Groundwater Application Review Summary Form

Application # G- 19055

TO: **Application G- 19055**

PUBLIC INTEREST REVIEW FOR GROUNDWATER APPLICATIONS

Well Location Map

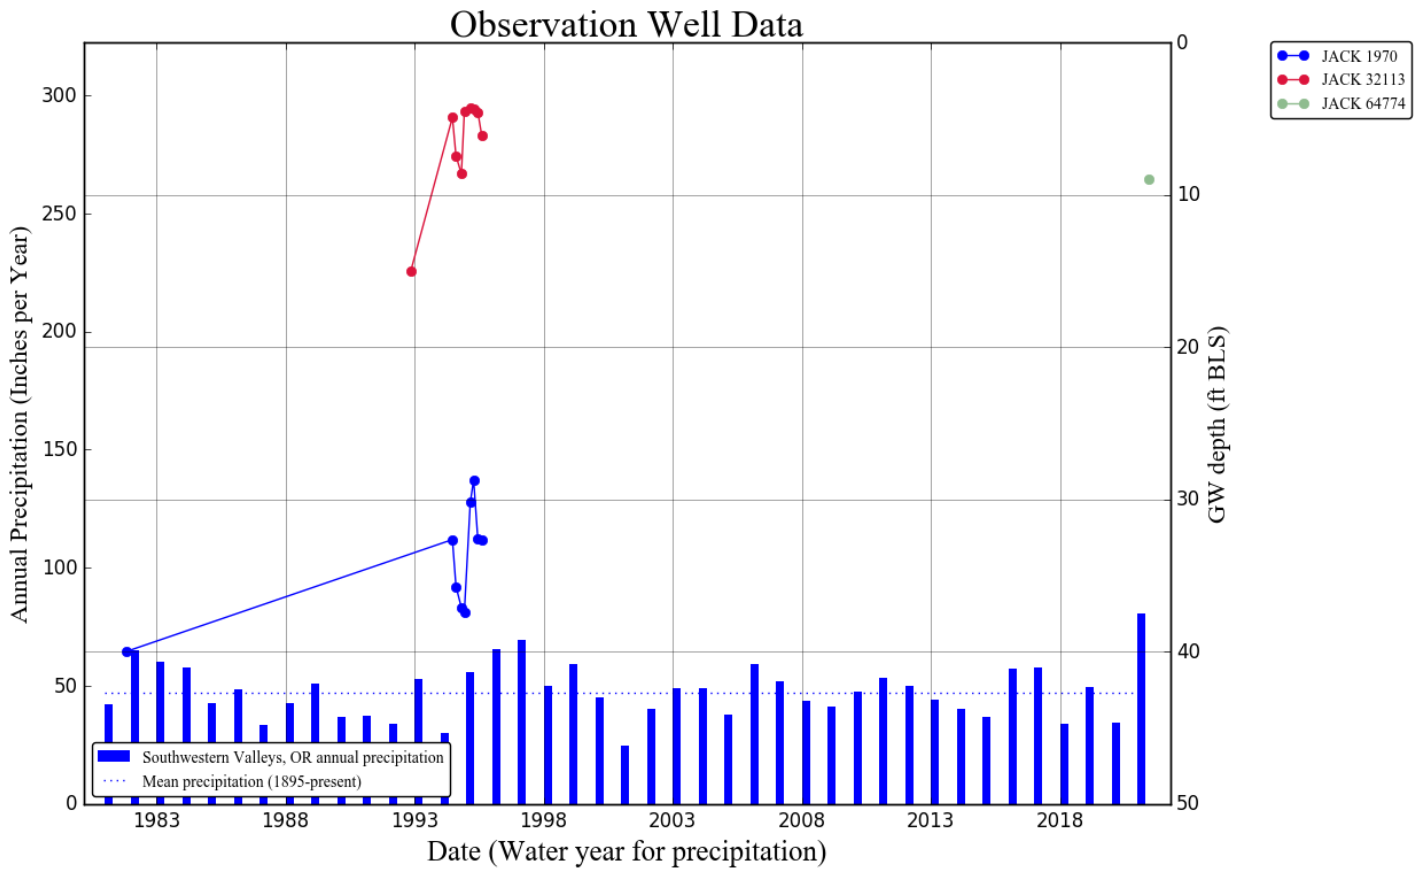
Because of the size of the applicant’s tax lot, there are no senior groundwater users within 1000 feet of the proposed POA. Considering the distance to adjacent wells, the low requested rate, and the presence of a nearby stream, there is a low probability that the requested use would cause well-to-well interference to the extent that would be considered injury to adjacent senior groundwater users.

C6. **SW / GW Remarks and Conditions:** The applicant's well accesses an aquifer that is determined to be hydraulically connected to Pleasant Creek. The proposed use is found to have the Potential for Substantial Interference (PSI) with Pleasant Creek by the following metrics as outlined in OAR 690-009: the well is located within ¼ mile of a surface water source, the requested rate (0.056 cfs) is larger than 1% of the expected natural stream flow (1% of 0.35 cfs or 0.0035 cfs), the requested rate (0.056 cfs) is larger than 1% of adopted instream flow (1% of 0.52 cfs or 0.0052 cfs), and the estimated stream depletion after 30 days is greater than 25%. A lower rate will not avoid a finding of PSI. Additionally, there are several recently constructed water wells on the applicant's property. It is noted that all of these wells appear to be located within ¼ mile of Pleasant Creek.
